Item Name: AS350/AS355 Quick Release Heli-Utility-Basket™ Long, Lightweight Lid

DART SERVICE INSTRUCTION

TO AMEND INSTALLATION INSTRUCTIONS D350-607-3 Rev.D,
INSTALLATION INSTRUCTIONS D350-607-4 Rev. C AND
INSTRUCTIONS FOR CONTINUED AIRWORTHINESS ICA-D350-607 REV.6
REF TCCA STC: SH94-14
REF FAA STC: SR00213NY
REF EASA STC: EASA.10016996
REF BRAZILIAN STC: 2007S03-03/-04/-05/-06

A	NEW ISSUE	AJS	14.05.16
REV.	DESCRIPTION	BY	DATE
DESIGN	AJS	DART AEROSPACE LTD HAWKESBURY, ONTARIO, CANADA	
DRAWN	AJS		
CHECKED		DRAWING NO.	REV. A
MFG. APPR.	N/A	DSI 9699	SHEET 1 OF 2
APPROVED		TITLE	SCALE
DE APPR.		LUG REPLACEMENT	NTS
DATE	14.05.16	COPYRIGHT © 2014 BY DART AEROSPACE LTD THIS DOCUMENT IS PRIVATE AND CONFIDENTIAL AND IS SUPPLIED ON THE EXPRESS CONDITION THAT IT IS NOT TO BE USED FOR ANY PURPOSE OR COPIED OR COMMUNICATED TO ANY OTHER PERSON WITHOUT WRITTEN PERMISSION FROM DART AEROSPACE LTD.

FIGURE 1: INSTALLATION OF D4775-041 FWD STRUT

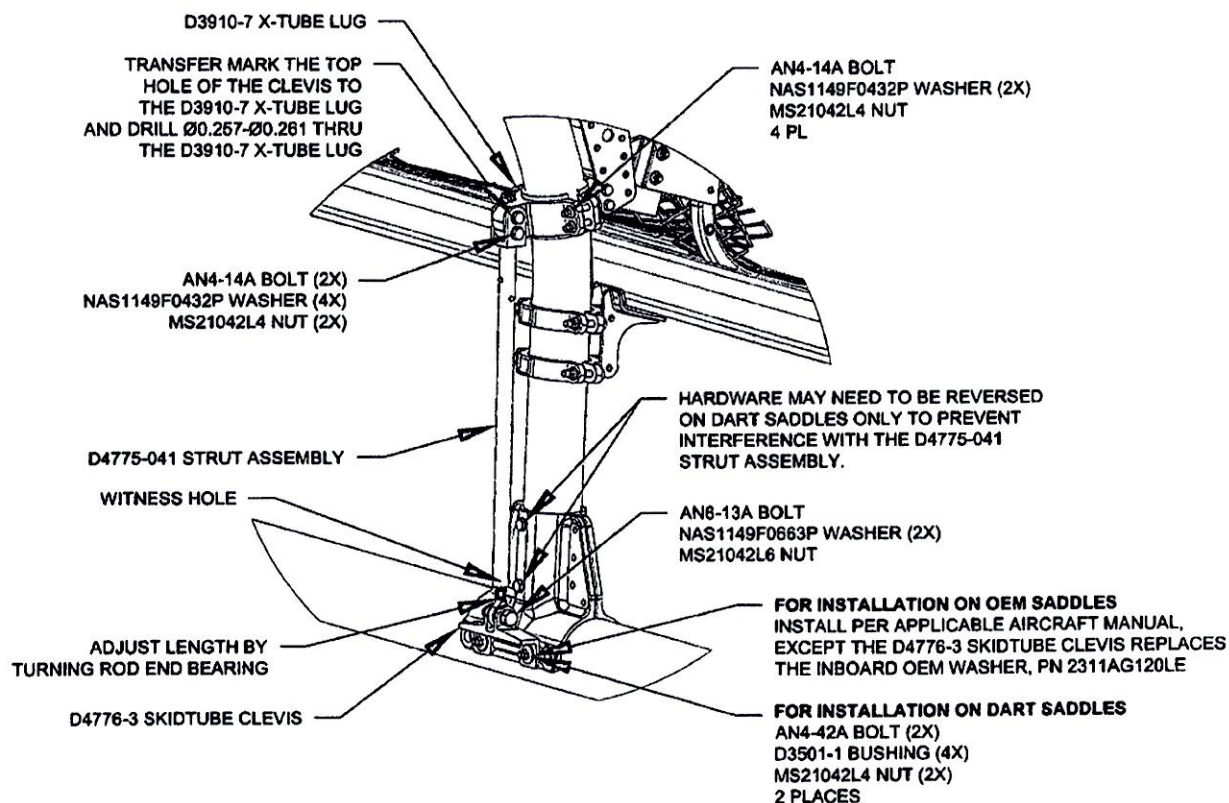
3.1 Substitute the Forward Lower D3910-5 X-Tube Lug with the D3910-7 X-Tube Lug as shown in Figure 1.

3.2 Install the forward D4775-041 Strut Assembly. Transfer mark from the upper hole on the clevis of the D4775-041 Strut Assembly to the D3910-7 X-tube Lug and drill thru the lug $\varnothing 0.257$ - $\varnothing 0.261$ as shown in Figure 1. Touch up chemical conversion coating per MIL-DTL-5541. Check the witness holes located at the bottom end of the D4775-041 Strut Assemblies to ensure that the thread from the rod end extends past the witness hole.
Torque MS21042L4/-4 nuts to 50-70 in-lbs (5.7-7.9 N-m). Torque MS21042L6/-6 nuts to 160-190 in-lbs (18.1-21.5 N-m).
